The Commission has issued the enclosed Amendment No. 86 to Facility Operating License No. DPR-31 and Amendment No. 79 to Facility Operating License No. DPR-41 for the Turkey Point Plant Unit Nos. 3 and 4, respectively. The amendments consist of changes to the Technical Specifications in response to your application transmitted by letter dated April 21, 1982, as supplemented April 22, 1982.

These amendments correct the Hot Channel Factor Normalization Operating Envelope.

SAFETY EVALUATION BY THE OFFICE OF NUCLEAR REACTOR REGULATION
RELATED TO AMENDMENT NO. 86 TO FACILITY OPERATING LICENSE NO. DPR-31
AND AMENDMENT NO. 79 TO FACILITY OPERATING LICENSE NO. DPR-41

FLORIDA POWER AND LIGHT COMPANY
TURKEY POINT PLANT UNIT NOS. 3 AND 4
DOCKET NOS. 50-250 AND 50-251

FIG. 3.2-3

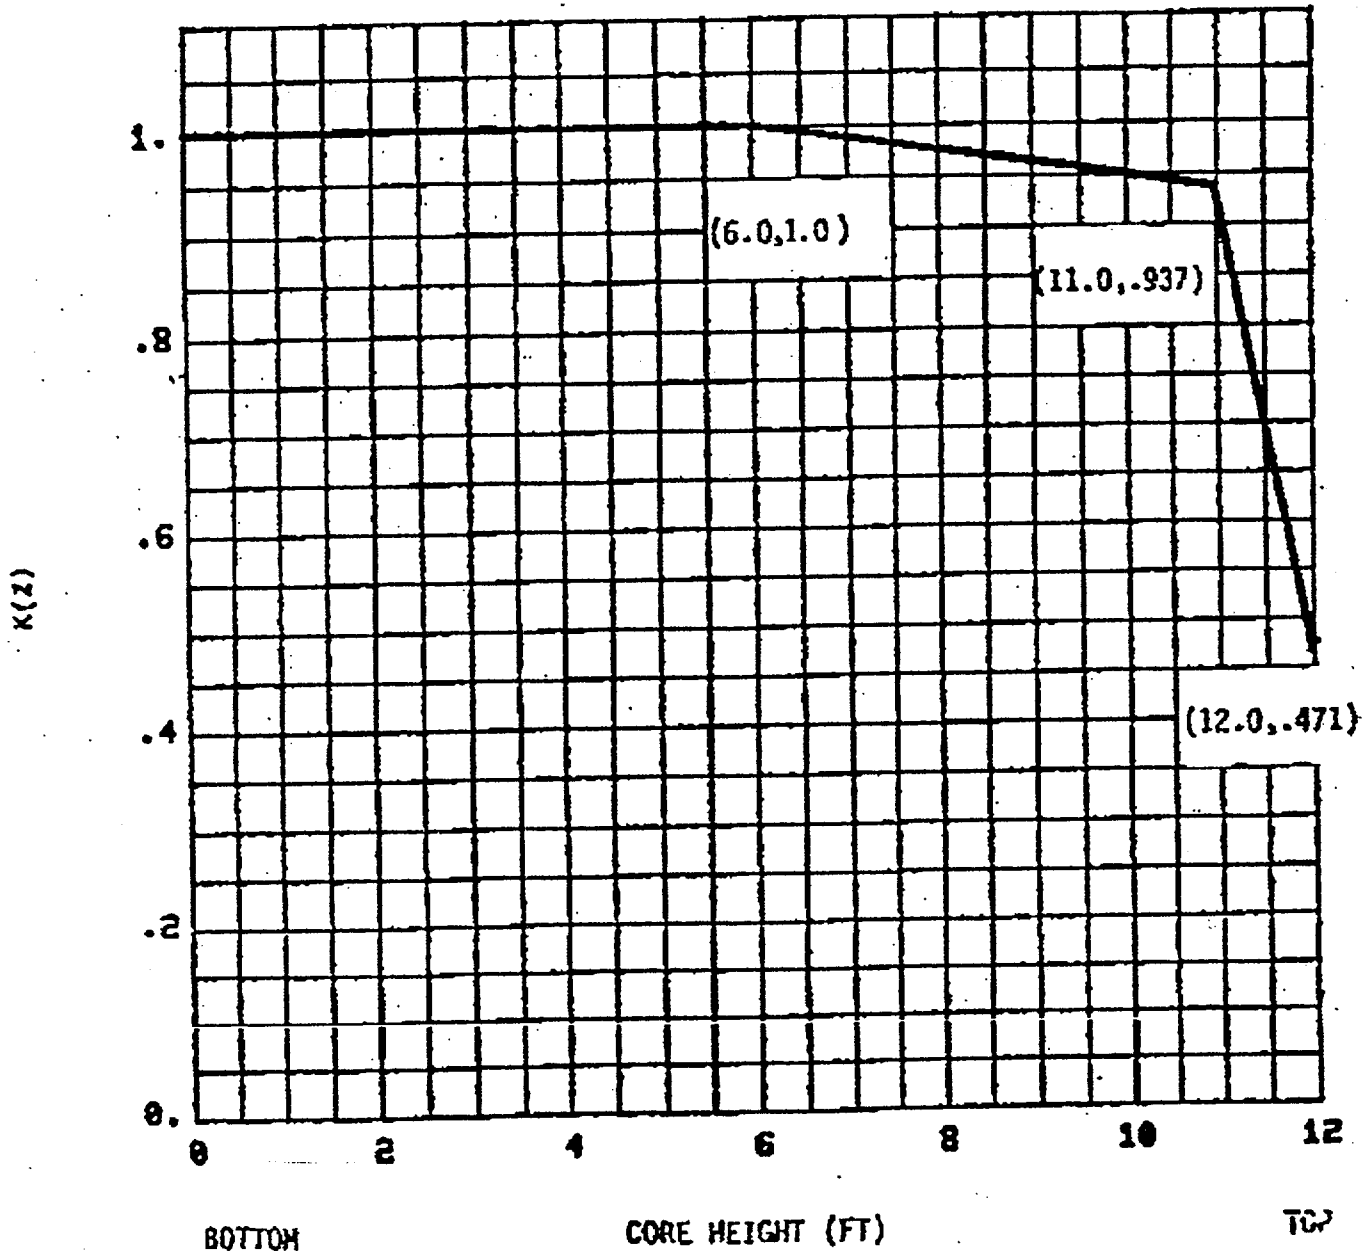
By phone call dated April 21, 1982, confirmed by a letter of the same date, as supplemented April 22, 1982, Florida Power and Light Company (the licensee) requested expedited action to amend the Technical Specifications for the Turkey Point Plant Unit Nos. 3 and 4. The amendments would replace an erroneous Hot Channel Factor Curve.

After Unit 3 began operation with the new steam generators it operated under the current $K(z)$ curve (i.e. for 28% steam generator tubes plugged) since the ECCS evaluation for the new steam generators had not been submitted to the NRC for review and approval. Upon completing the necessary surveillance measures it was determined that the $K(z)$ curve was in error.

Based on investigation by Westinghouse and the licensee of Figure 3.2-3 of the Turkey Point 3 and 4 Technical Specifications, it has been determined that the currently docketed figure is incorrect. Based on Westinghouse investigations it appears that the intercept of the second and third line segments in the region of 11 feet in core height has been incorrectly calculated for an $FQ(Z)$ of 2.125. The current intercept coordinates of 11.2 feet, 0.849 reflect an incorrect calculation based on the use of FQ value of 2.125. Westinghouse has determined that the correct coordinates for the intercept should be 11.0 feet, 0.937. The licensee proposes that Figure 3.2-3 be modified to reflect the following break points:

0 feet	1.0
6.0 feet	1.0
11.0 feet	0.937
12.0 feet	0.471

Based on the conference call and the supplemental application the staff finds that error was properly corrected and the new $K(z)$ curve is acceptable. Previous operations under the old $K(z)$ curve which was in error did not violate any Technical Specifications because the incorrect $K(z)$ curve was conservative relative to the corrected curve.
